Technical Service Bulletin: TSB230228

ReCon® Engines Without Electronic Control Modules (ECM)

Figure 1, Hang Tag Put in Place of the ECM.

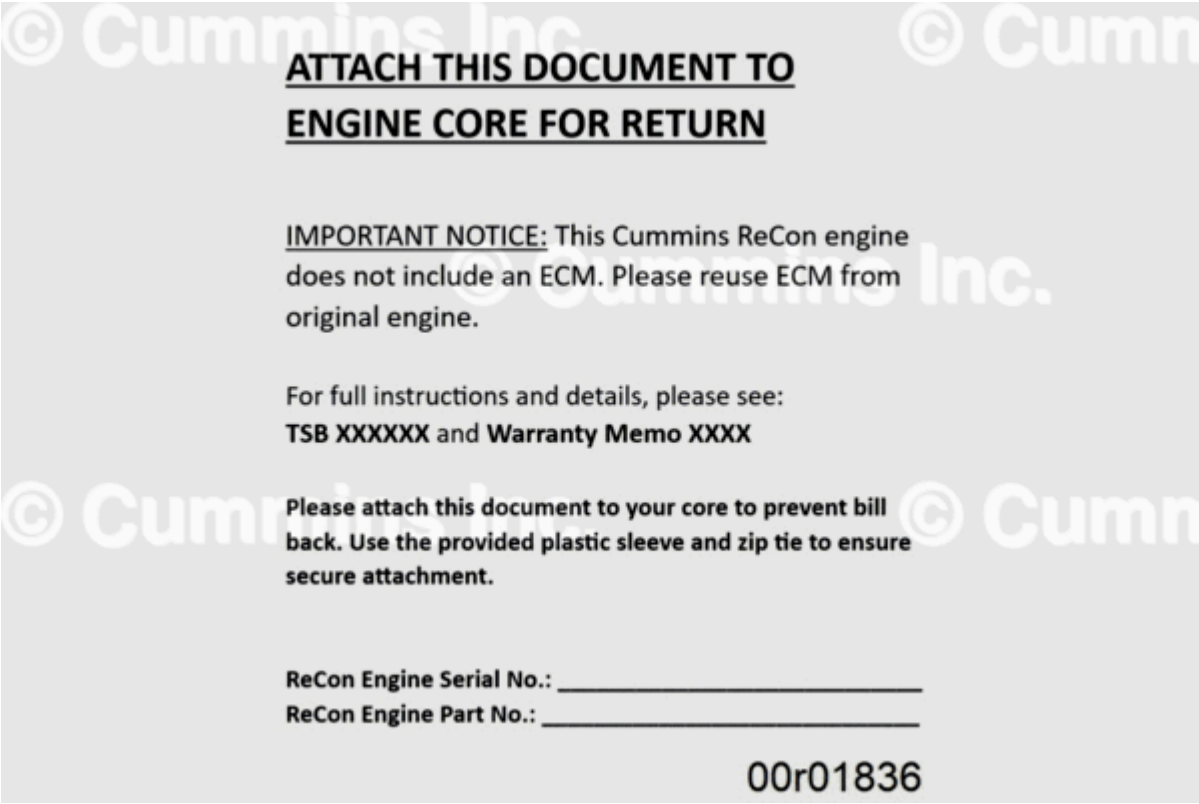
- Update with latest ECM calibration available. See corresponding Service Manual. Reference Procedure 019-032 in Section 19.
- Update the Engine serial number in ECM with ReCon® engine serial number.
- All affected ReCon® engines will arrive with a hang tag (see Figure 1 below) in place of the ECM. This hang tag **must** be attached to the core engine prior to being returned.
